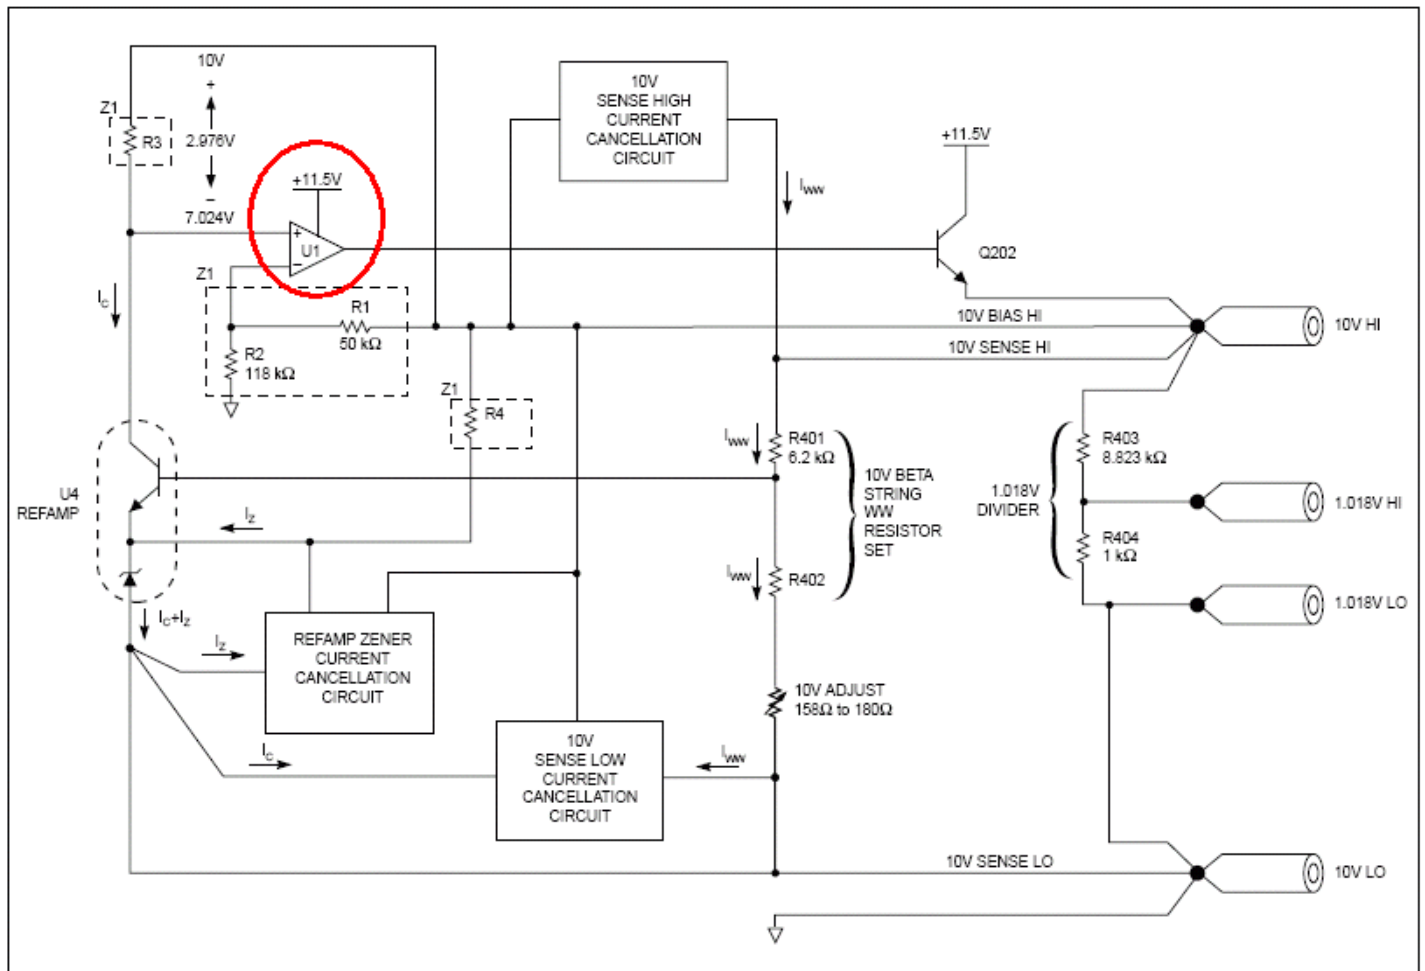
The circuit diagram of 732A is not a whole and it is difficult to use. Although some people have included me, I have drawn a complete circuit diagram. Here I just refer to the block diagram. To illustrate: the power supply of the op amp is still from the 10V output:

Or post a 732A circuit diagram (local) compiled by a foreign enthusiast. After the short circuit, the main current comes from the R3 and Q2 current limit, which is about $0.65V / 24.3R = 26.7mA$, plus the 1mA current of CRD13, which is consistent with the test value.

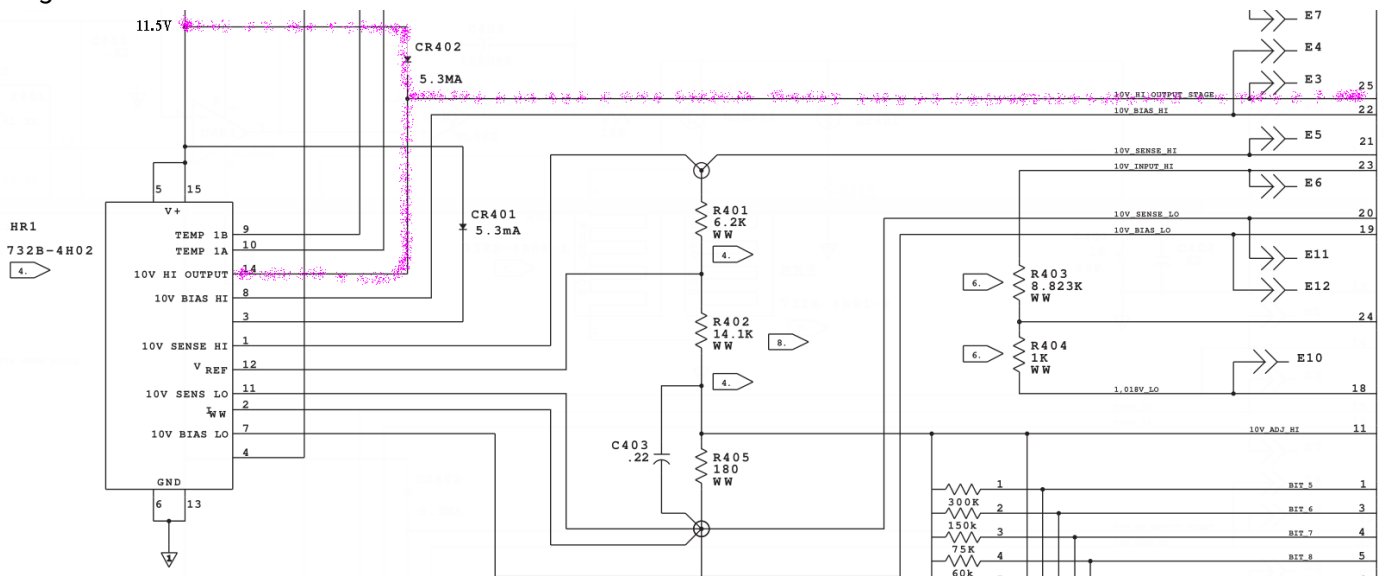
After the output is short-circuited, the red path provides nearly 30mA (0.65V / 22R), and the other 30mA is provided by the purple path.

The purple part is divided into two parts, one is a 5.3mA constant current tube, and the other is a mysterious black box HR1 with no specific circuit diagram, 14 feet.

It is not known why Fluke increased the constant current tube from 1mA to 5.3mA. In fact, the magnification of the output tube 2N3904 is sufficiently large. The maximum $I_b < 0.1mA$ is guaranteed at 10mA, and 1mA is 10 times the margin.

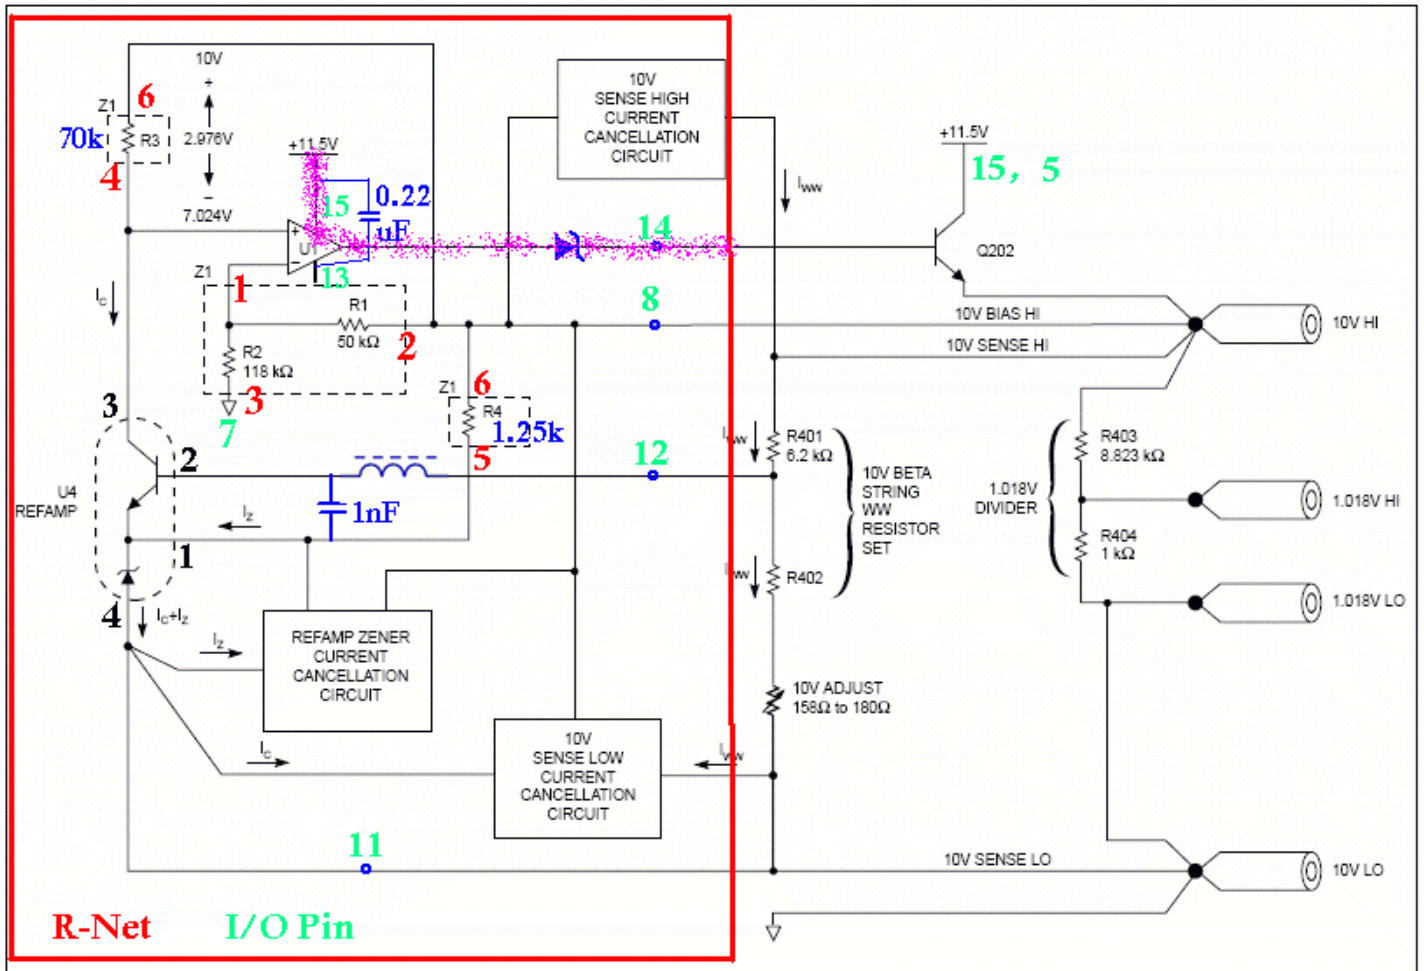
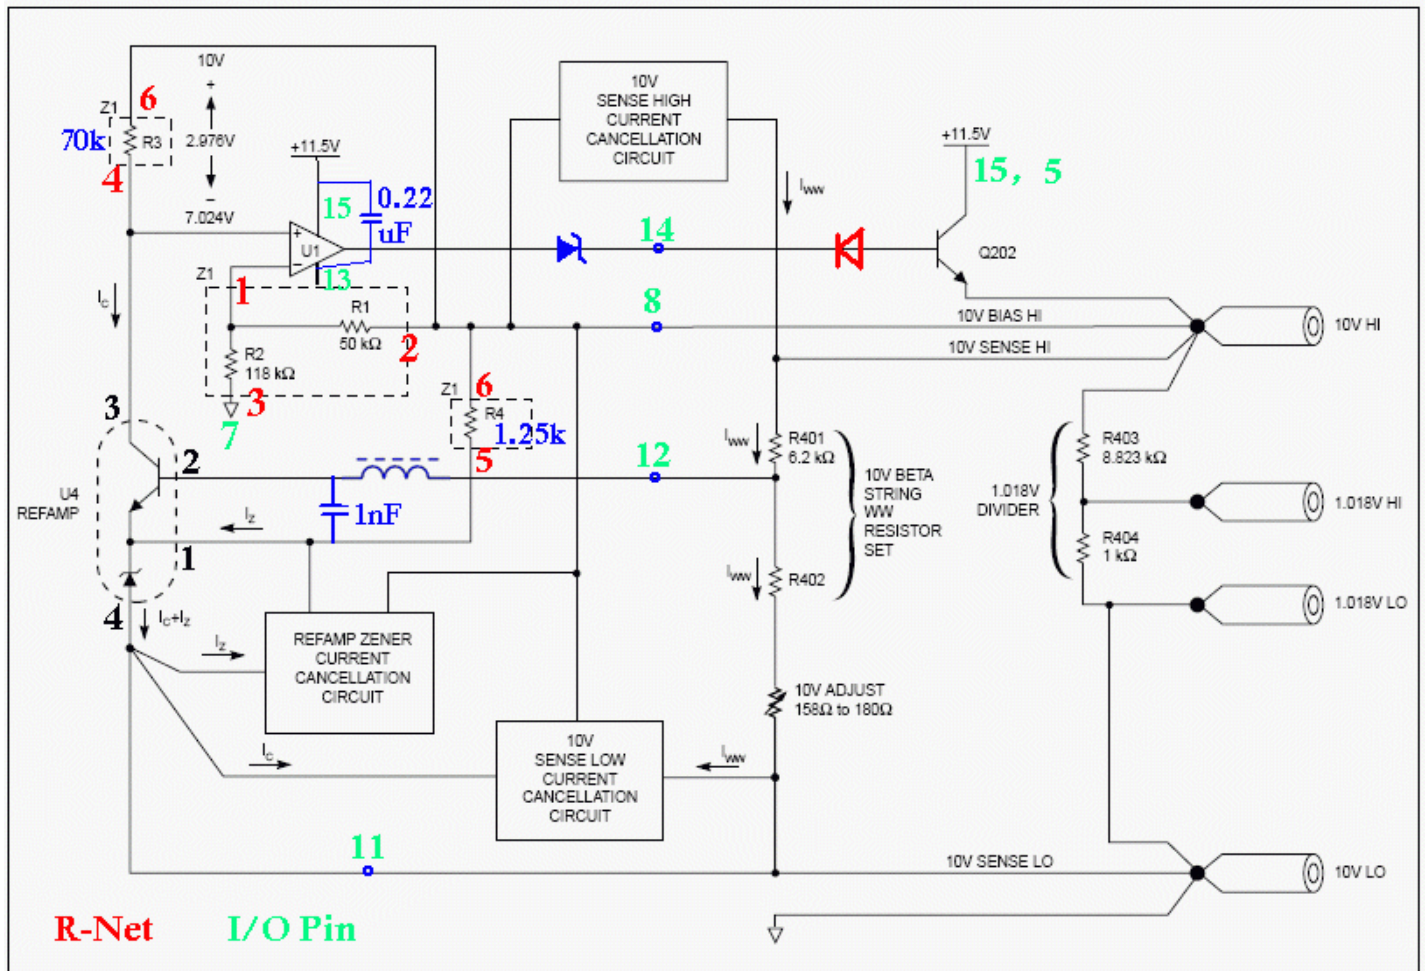
This black box has no specific circuit diagram, but there is a block diagram, which is in the red box below. I have marked and added the necessary components that actually exist such as the blue voltage regulator tube (note: the red area is not the thermostatic bath area. Constant temperature The slot is larger than this range,

Obviously, because the op amp is connected to a 11.5V power supply, the op amp is always powered when the output is shorted, but the voltage of the green 12 pin is very low, causing the op amp + input to be much larger than the-input, and the output of the op amp is very high. The voltage tube provides current to the green 14 pin. This current is actually the current limit of the op amp. Therefore, the op amp works in the limit state. Although it will not be damaged, it will generate heat. It is about $11.5V \times 20mA = 230mW$, so it will recover after a short circuit. All become problems.

The earliest 731A was the direct output of the op amp. There was a problem with the current limit of the op amp after the output was shorted. 731B has been improved, but 732B was changed back and became a design flaw.

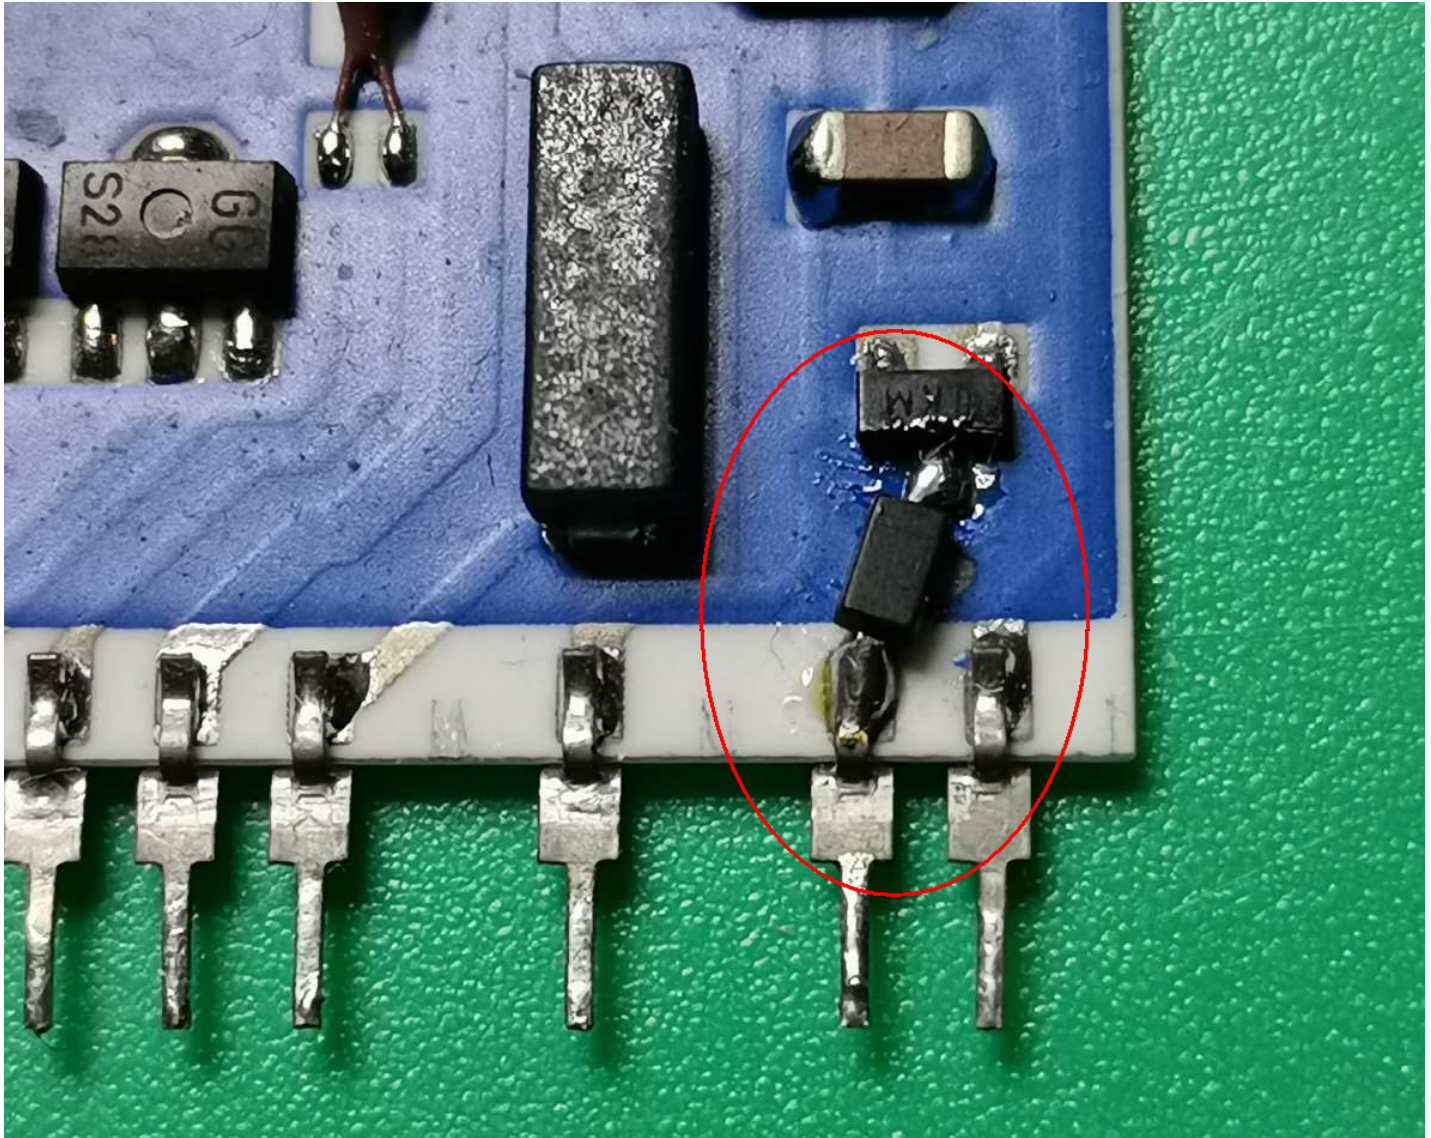
The simplest improvement is to add a red diode as shown below

This diode is forward-biased during normal operation. There is no relationship with a voltage drop of 0.65V. Anyway, this voltage drop is mainly in the voltage regulator tube. Fluke is a constant current diode that sinks current to the op amp during normal operation. .

Once short-circuited, the output of the op amp is saturated, and the right end of the diode is low, so the diode is reverse biased, there is no current, and the op amp has no output current, which is truly protected.

The photo of the circuit board with a diode added is as follows:

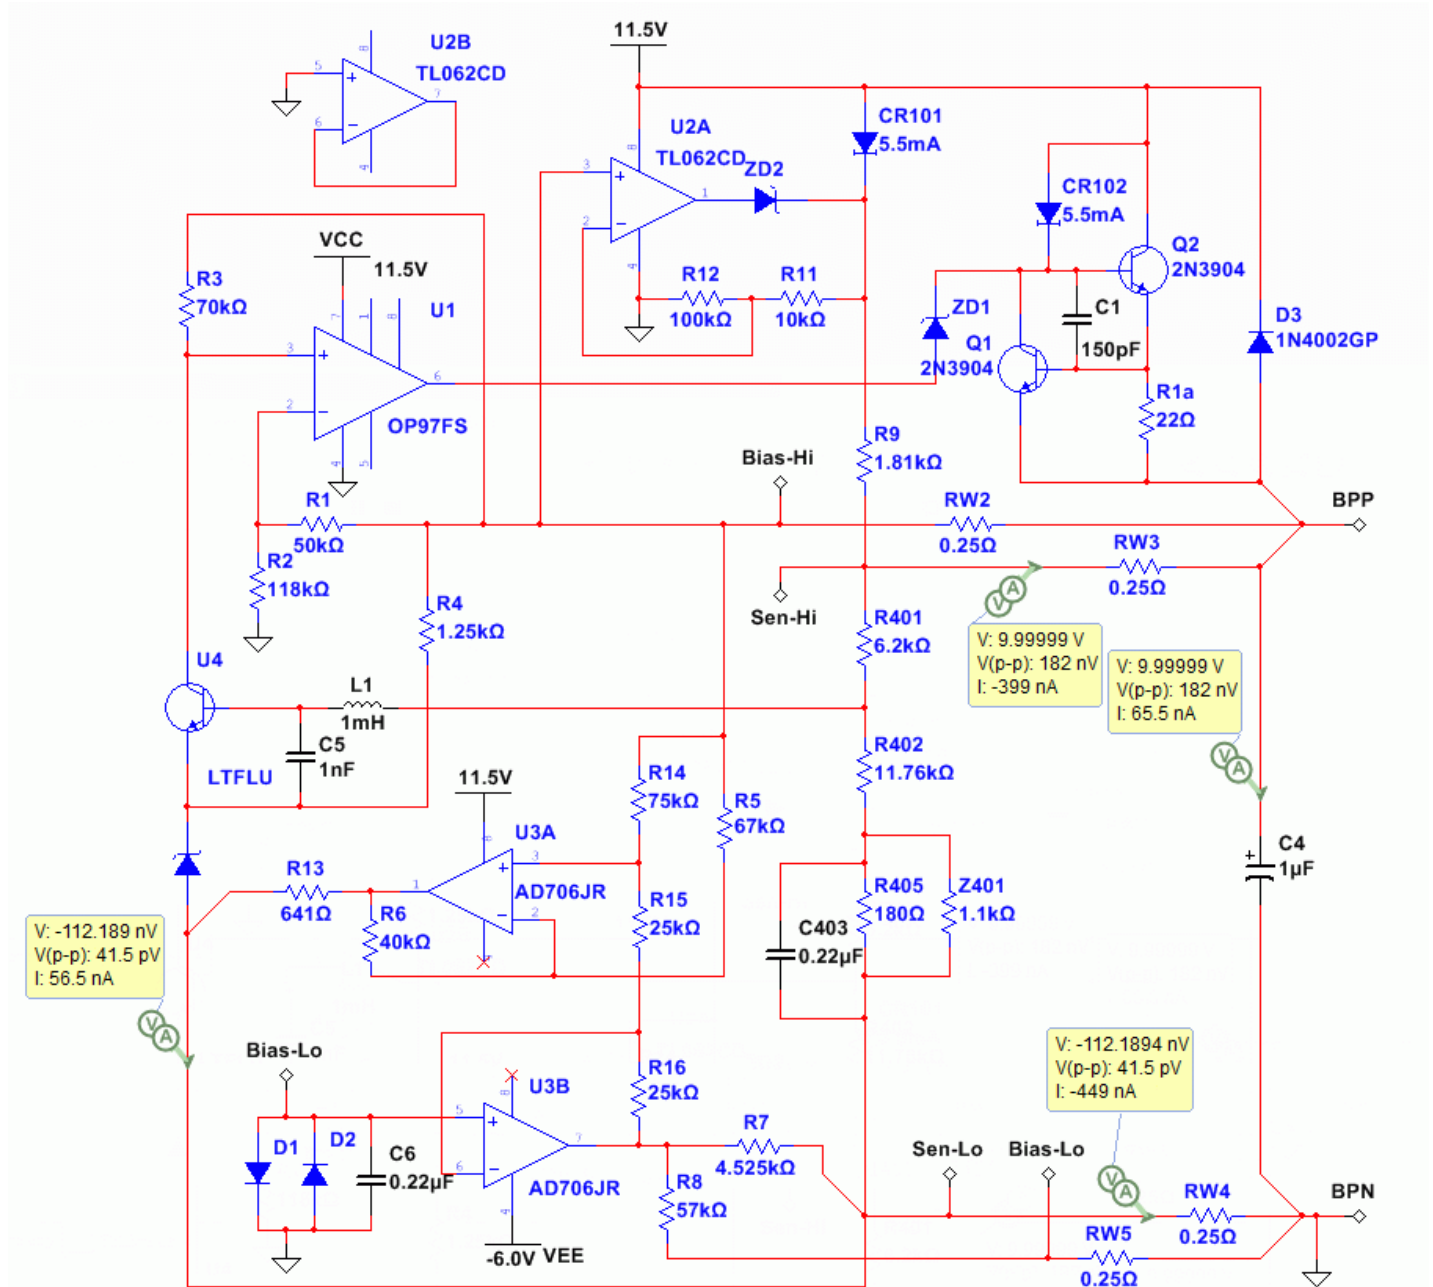
This circuit has passed simulation, and the compensated currents are all below 0.5uA (less than 0.1%).

For detection compensation, the compensation current needs to be $10 / 17.87 = 0.56\text{mA}$. There is already a 1.8k compensation resistor, so a voltage of 1.0V is required. This is easy. R11 and R12 can be divided.

Under test compensation, $R7 = 4.5\text{k}$ is required, and the voltage is $-0.56 * 4.5 = -2.5\text{V}$. This is also very easy. R14 to R15 can be divided from 10V.

The ground current compensation of the voltage regulator is more difficult. Only the voltage division of R5 and R6 is known. In addition, the voltage regulator current = 3mA is also known. Finally, the reference voltage is + 2.5V and the output is 2.0V / 1.98V. It is obtained through the partial pressure of R14 and R15, while $R13 = 1.98 / 3 = 660$ ohms.
